# Optimizing the Heathkit HW-101, SB100-102 Transceivers

The Heathkit HW/SB series of transceivers were very popular in the late 60's through 70's and are fairly plentiful on the used market even today, nearly 30 years later. This series of modifications will increase the audio quality of both receive and transmit, improve operation on CW, enhance strong signal handling of the rigs, and make the units useable with the low-Z headphones so often used today. All of these changes require no hole drilling or mechanical changes at all, and the rig can be easily restored to its original configuration at anytime if desired. The text deals with the HW-101, but the changes are applicable to the above mentioned SB-series as well.

Figure 1

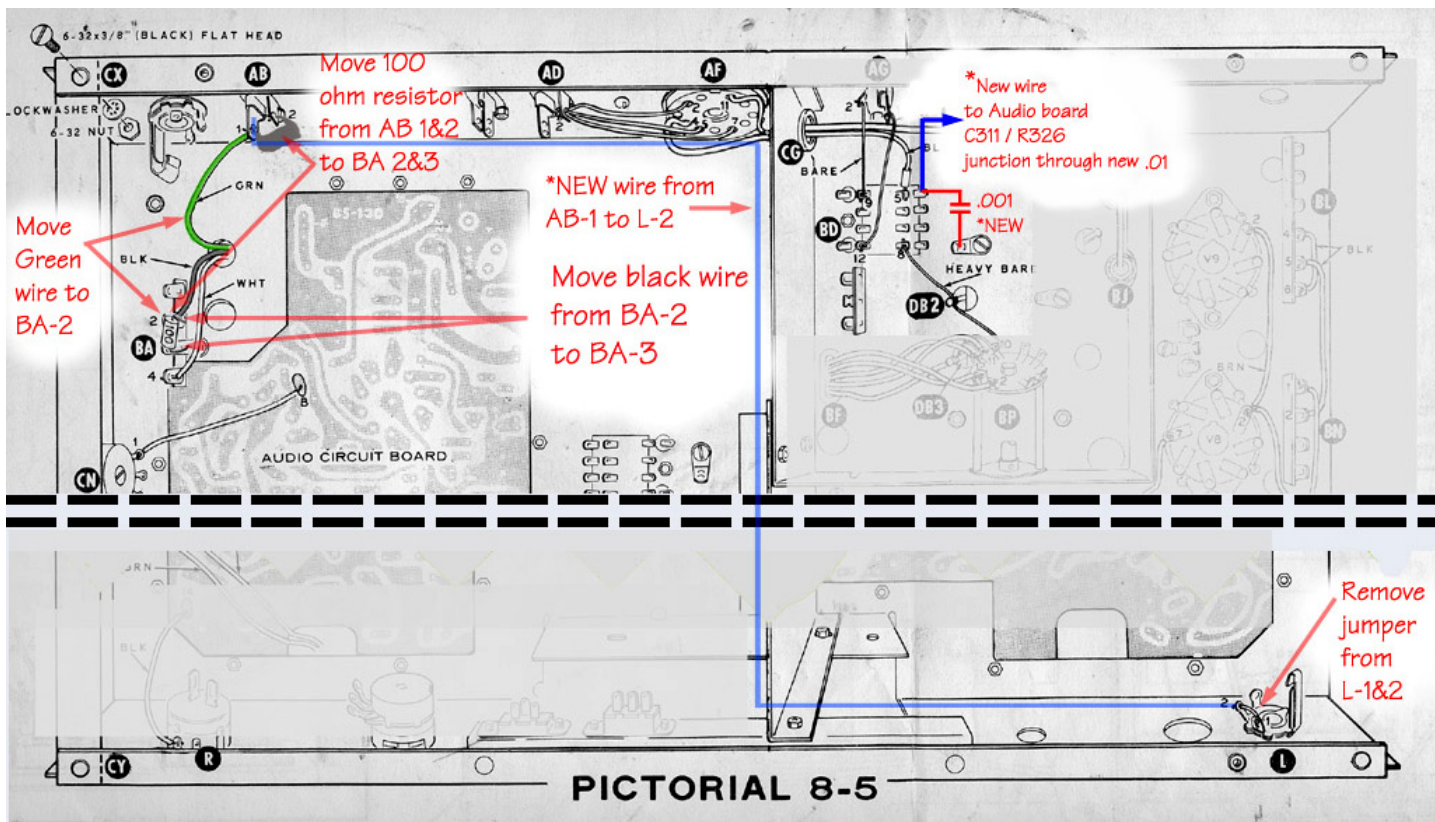
These rigs are designed to be used with Hi-Z headphones, but if low-Z phones are used the outboard speaker will not mute completely with the phones connected. To convert to low-Z phones, make the following wiring changes referring to *(Figure 1)* of this document, and pictorial 8-4 (foldout from page 53), and pictorial 8-5 (foldout from page 67) of the HW-101 manual:

- 1.) Remove the black wire from terminal strip BA lug 2 and reconnect it to lug 3 (ground).
- 2.) Remove the green wire and the 100Ω resistor from jack AB (speaker).
- 3.) Connect the green wire to terminal strip BA lug 2.
- 4.) Connect the 100Ω resistor removed in step 2 to lugs 2 and 3 of terminal strip BA.
- 5.) Remove the jumper wire from lugs 1 and 2 of headphone jack L.
- 6.) Run a NEW wire along the wiring harness from speaker jack AB lug 1 to the headphone jack lug 2.

- 1) Connect a .001  $\mu$ fd disk capacitor (DO NOT use a higher value) from relay RL1 pin 1, to ground (**Figure 1**).
- 2) Connect a piece of wire about 8" long from pin 1 of RL1 and run this wire through the same opening in the shield as the wiring harness.
- 3) On the audio circuit board, replace 1M $\Omega$  resistor R326 with a 2.2M $\Omega$  resistor (**Figure 2**).
- 4) At the circuit board junction of R326 and C311, connect one side of a .005  $\mu$ fd 500v disk capacitor, and connect the other side of this capacitor to the wire from RL1 pin 1.

Figure 2

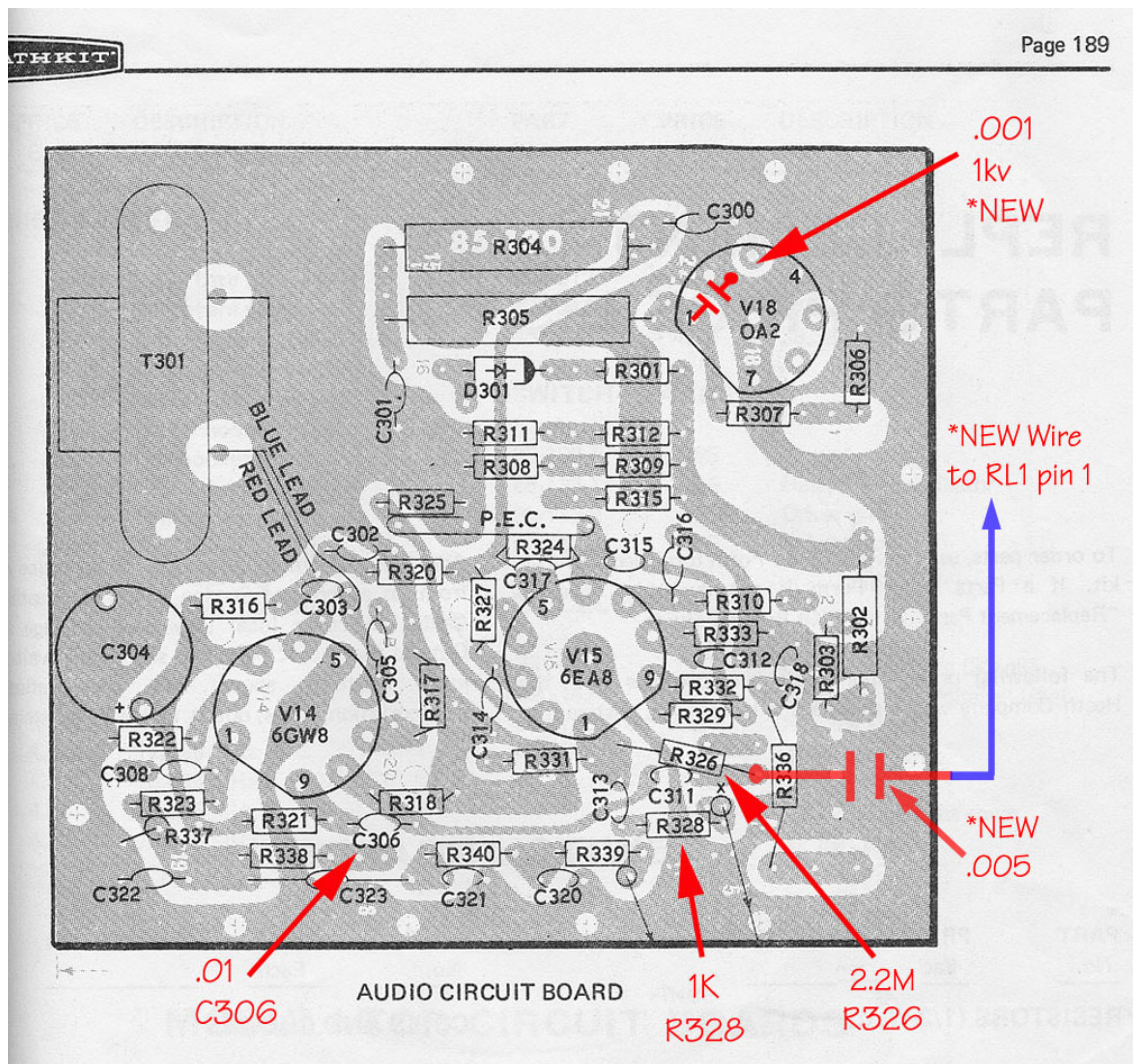
Additional rolloff of the high frequency response will remove the raspy nature of the receive audio, and this is accomplished by changing the value of capacitor C119 on the I.F. board from 500pf to .001  $\mu$ fd (**Figure 3**). The low-end audio response of the audio amplifier increases slightly by replacing coupling capacitor C306 on the audio board with a .01  $\mu$ fd disk capacitor (**Figure 2**).

Figure 3

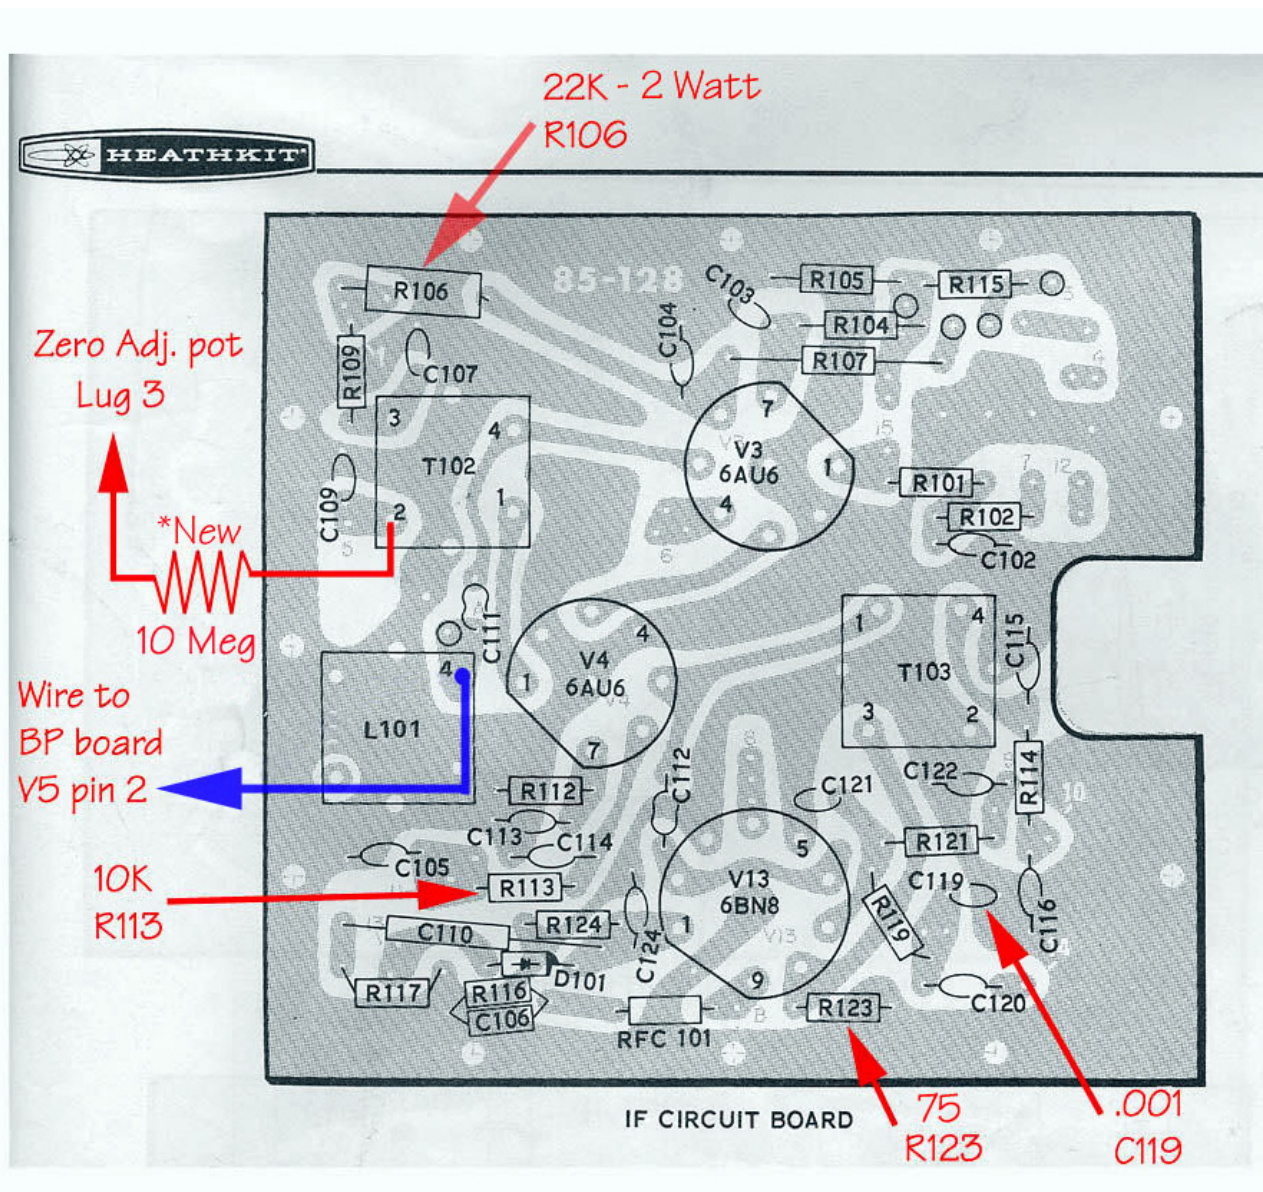
If 10K $\Omega$  resistor R202 is present between the I.F. circuit board (L101 pin 4) and the bandpass circuit board (V5 pin 2), remove and replace it with a piece of insulated hook up wire (**Figure 3**). This will increase drive to the 1<sup>st</sup> transmit mixer. This change is already incorporated in later model HW-101s.

During alignment check to see if, while adjusting T-102 (**Figure 3**), there are two points where the transformer can be peaked -- one spot for transmit and a slightly different setting for receive. If so, peak the transformer for maximum transmit drive instead of maximum receive gain. The receiver has an abundance of gain, however the transmitter could use a little extra. This will get rid of some of the receiver gain but WILL NOT affect receiver sensitivity.

Also change the value of the screen dropping resistor R113 in the second I.F. amplifier V4 from 1K $\Omega$  to 10K $\Omega$  (**Figure 3**). This will reduce the gain of this stage a bit and improve gain distribution.

To increase BFO drive, simply replace coupling capacitor C17 on the modulator board with a 100pf silver mica, and replace the 33K $\Omega$  resistors R6 and R7 on the modulator board with 27K $\Omega$  resistors (**Figure 4**). To reduce I.F. drive, change resistor R123 on the I.F. board from 470 $\Omega$  to 75 $\Omega$  (**Figure 3**).

S-meter zero setting instability is mainly caused by heat-related resistance changes in the R106 22K $\Omega$  1-watt resistor on the I.F. board. Replace R106 with a 22K $\Omega$  2-watt wirewound (*Figure 3*).

Figure 4

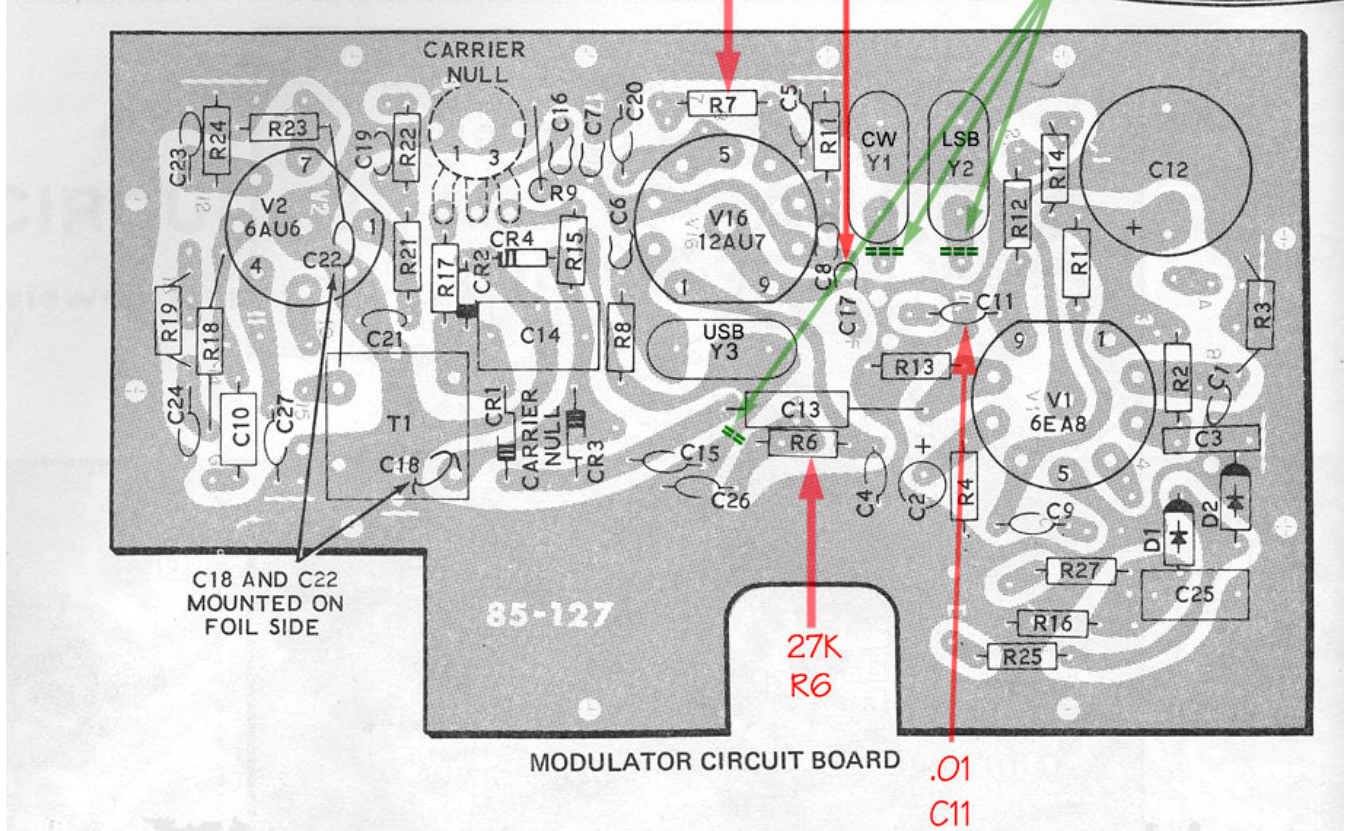
The transmitter audio quality can be improved by changing the value of coupling capacitor C11 on the modulator board from .001  $\mu\text{f}$ d to .01  $\mu\text{f}$ d (**Figure 4**). This will increase the low frequency response and give the transmit audio a little more “body”.

Figure 5

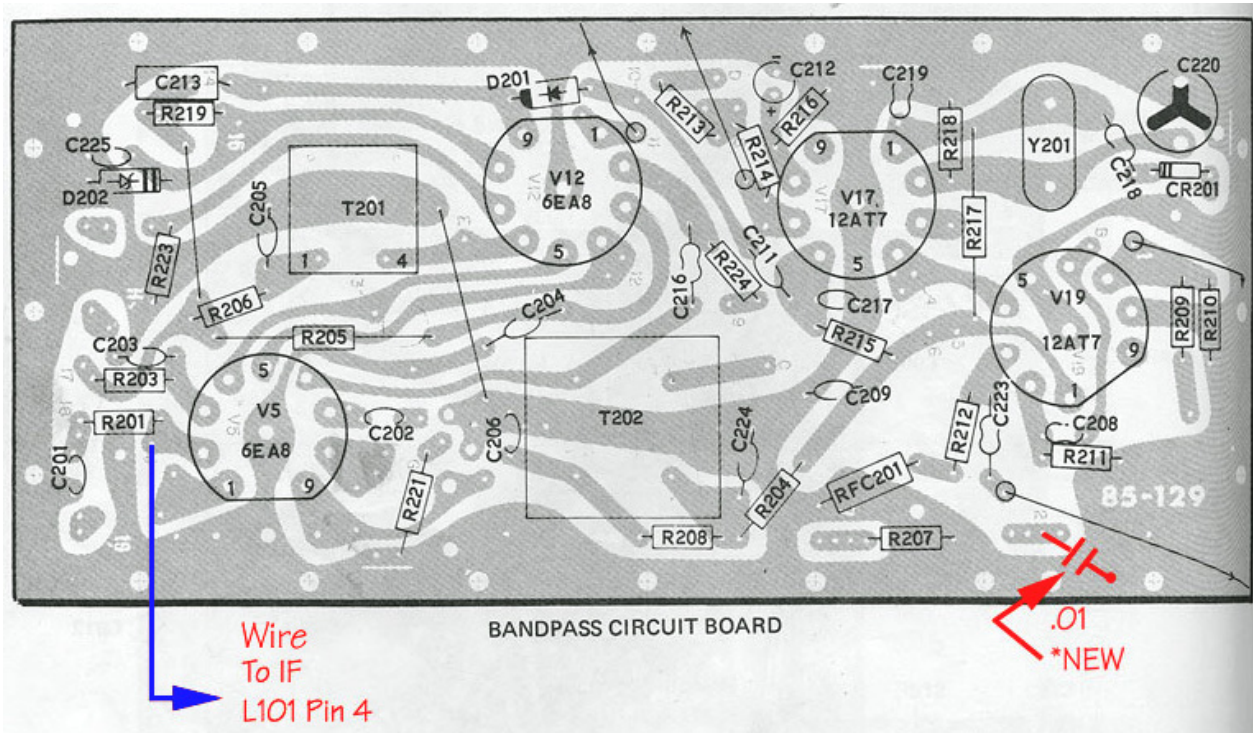
Some of the 'birdies' and other internally-generated signals heard in the tuning range of the receiver are reduced considerably by bypassing the filament string to ground with a .01  $\mu$ fd capacitor connected from the common filament point on the bandpass circuit board to ground. This is the point where the four brown wires connect about an inch below pin 1 of V19 (**Figure 5**).
